Re: DOCKET NO. 483 - The United Illuminating Company application for a Certificate of Environmental Compatibility and Public Need for the Pequonnock Substation Rebuild Project that entails construction, maintenance, and operation of a 115/13.8-kilovolt (kV) gas insulated replacement substation facility located 700 feet southwest of UI's existing Pequonnock substation on an approximately 3.7 acre parcel owned by PSEG Power Connecticut, LLC at 1 Kiefer Street, Bridgeport, Connecticut, and related transmission structure and interconnection improvements.

Interrogatory CSC-2-29

The United Illuminating Company
Docket No. 483

See attachment CSC-2-29 for location details of the chamber in question.

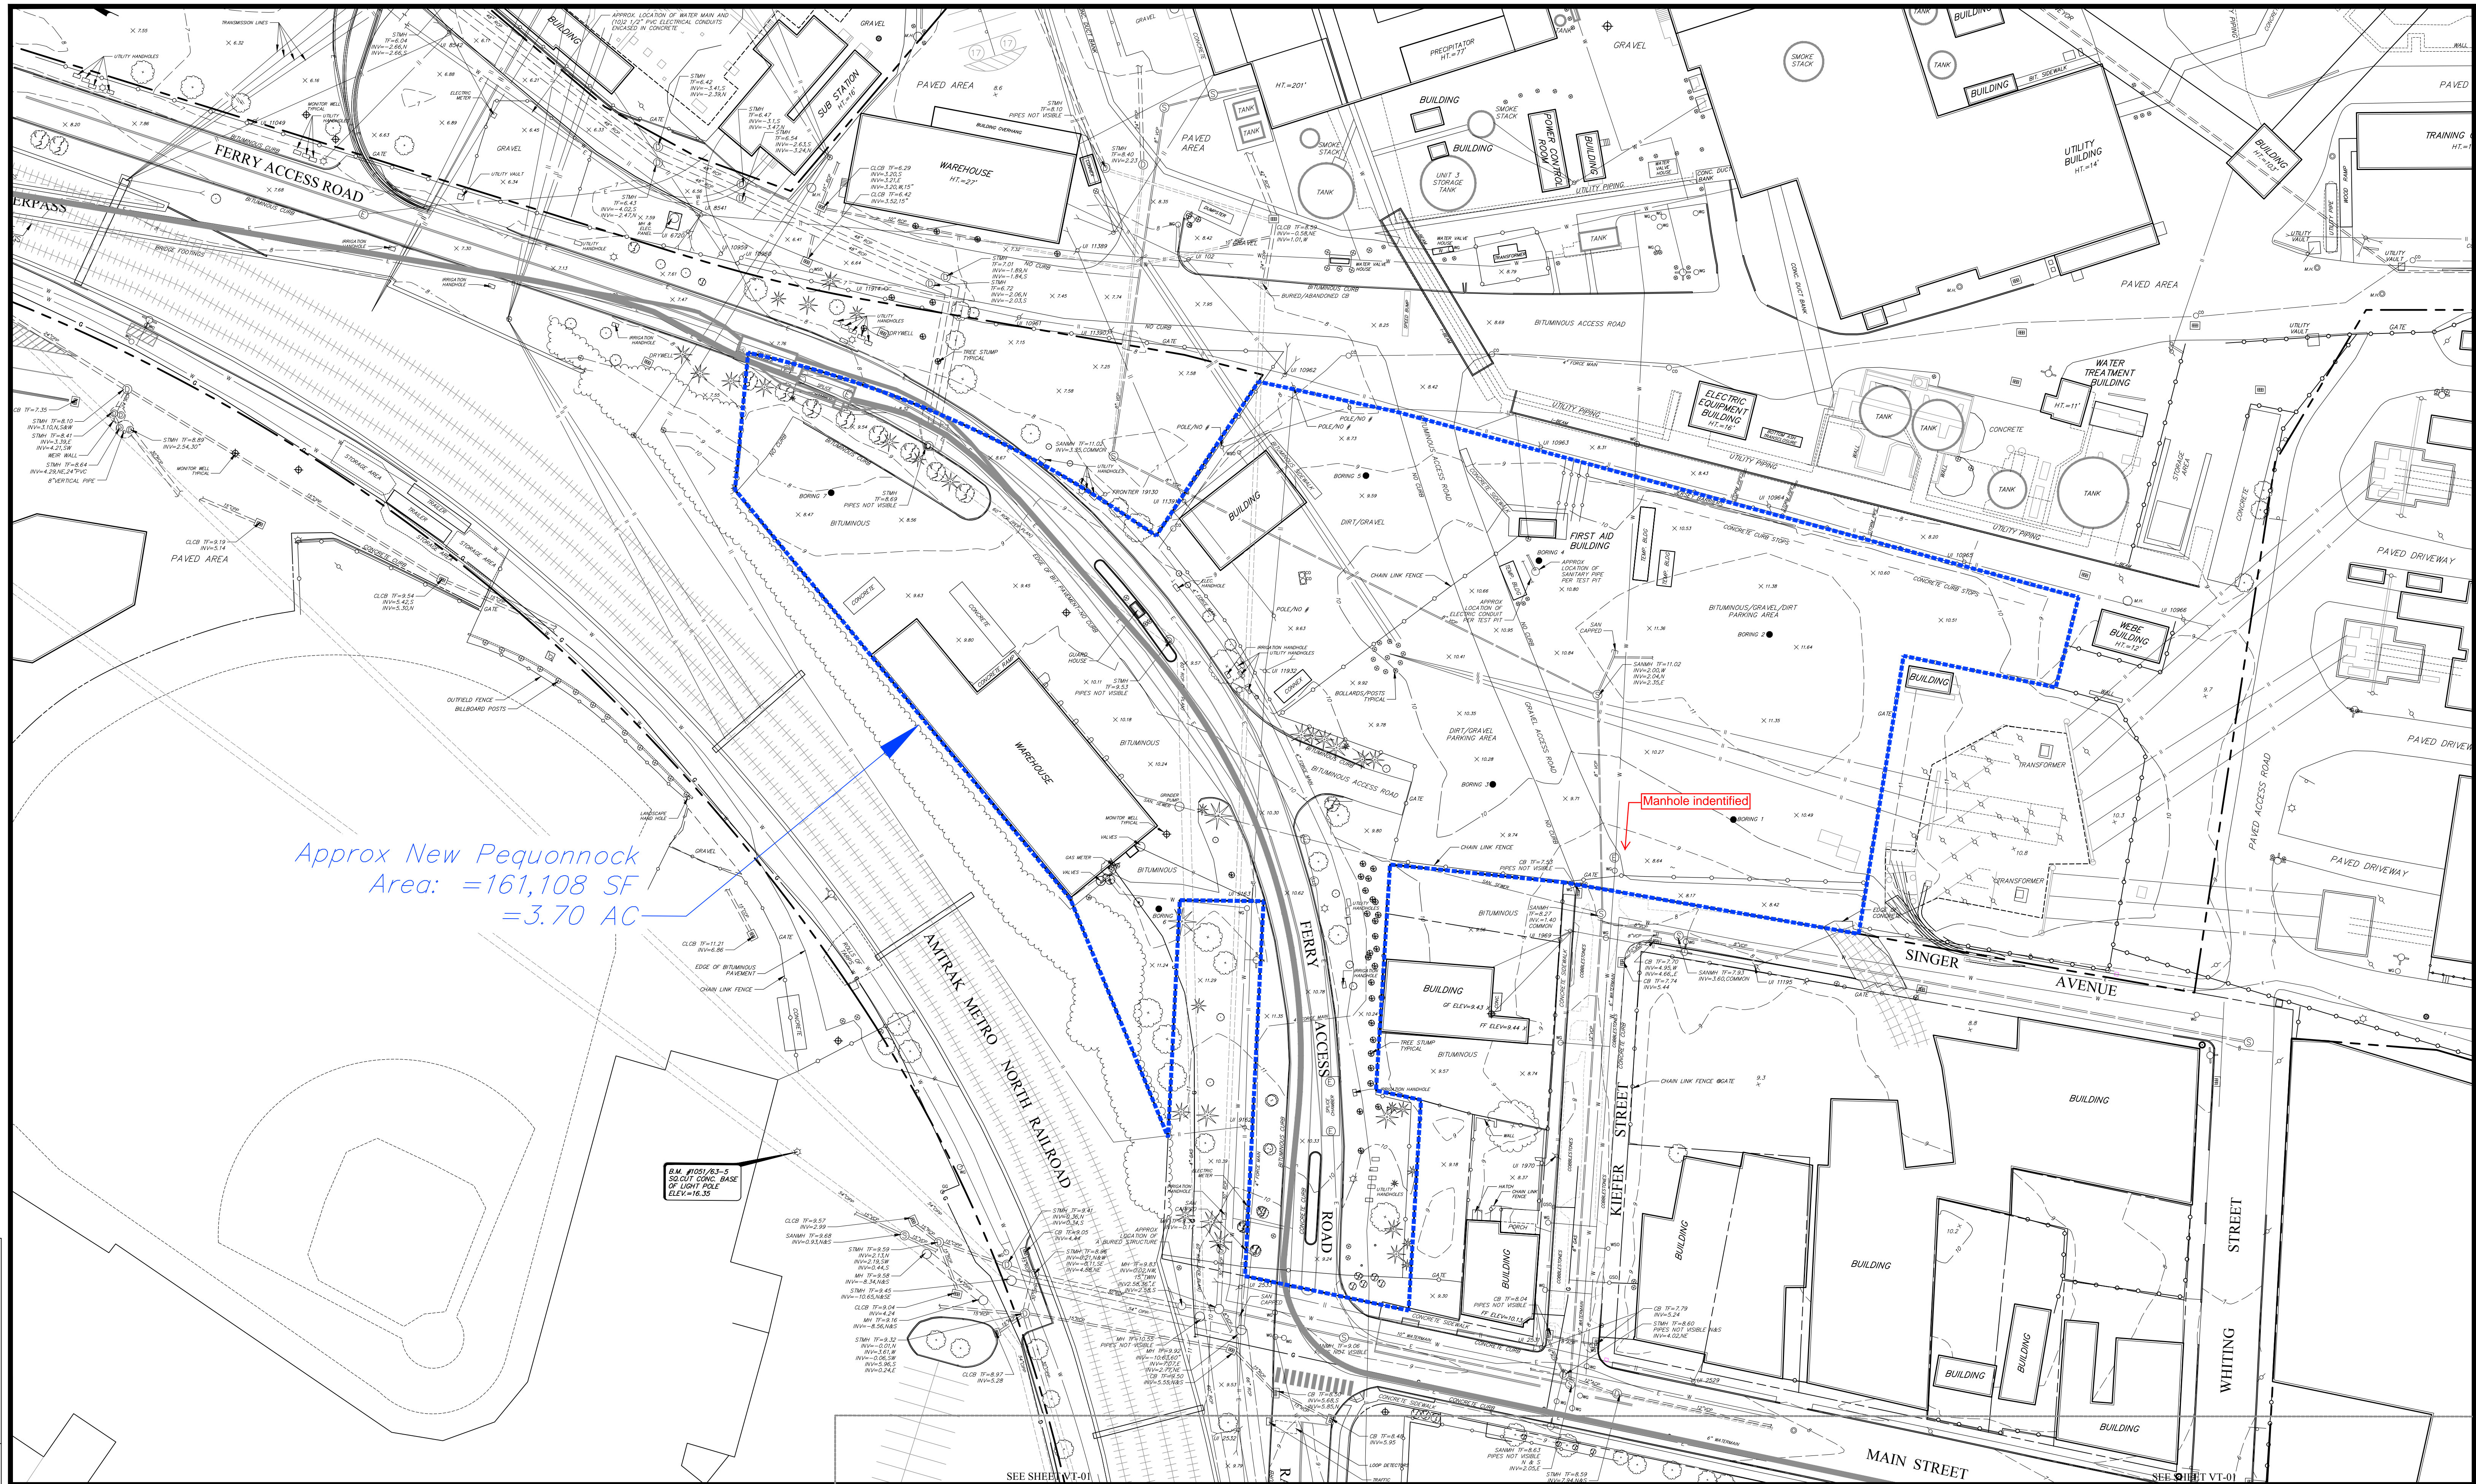
Q-CSC-2-29: Referencing Figure ES-5 of the United Illuminating Company's (UI) Application, there appears to be an existing paved access drive on the southern portion of the site that runs in a roughly northeast to southwest direction. What is the purpose of an existing manhole cover roughly near the south side of that existing access drive?

A-CSC-2-29: The cover in question on the south side of the existing access drive on the proposed site is marked "Electric". UI investigated the manhole and determined that the cover is incorrectly marked and within the chamber there appears to be a water line. During detail engineering UI will determine the owner and purpose of this water line and make plans to relocate this facility.

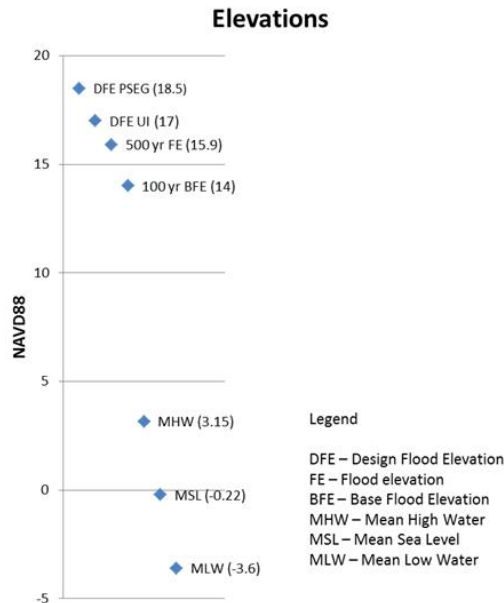
Q-CSC-2-35: At the June 14, 2018 evidentiary hearing, comparisons were made between the (administratively noticed) Petition No. 1218 PSEG Bridgeport Harbor Unit 5 Project design elevation and UI's proposed replacement substation elevation. The data are provided in the table below. Please comment on difference between the design elevations of the two adjacent projects.

UI estimated a 500-year flood elevation that was 0.6 ft. higher than the elevation estimated by PSEG. This higher estimation is the result of including greater wave effects, due to higher winds, during the 500-year flood than during the 100-year flood.

UI identified a Design Flood Elevation (DFE) of 17 ft. NAVD88 based on an industry guidance of Base Flood Elevation (BFE) + 3 feet, which includes 1 ft. to account for future sea level rise. As stated in the CCCS, PSEG originally used a design flood elevation of 16.5 ft. NAVD88. However, according to a later document the design flood elevation (top of concrete) is actually 18.5 feet NAVD88 or BFE +4.5 feet (CSC Petition # 1218, Exhibit B – Preliminary Site Development Plans, Figure B-1 General Arrangement, Design note 2 on Drawing # BPHU5-DWG-014-C-0102).
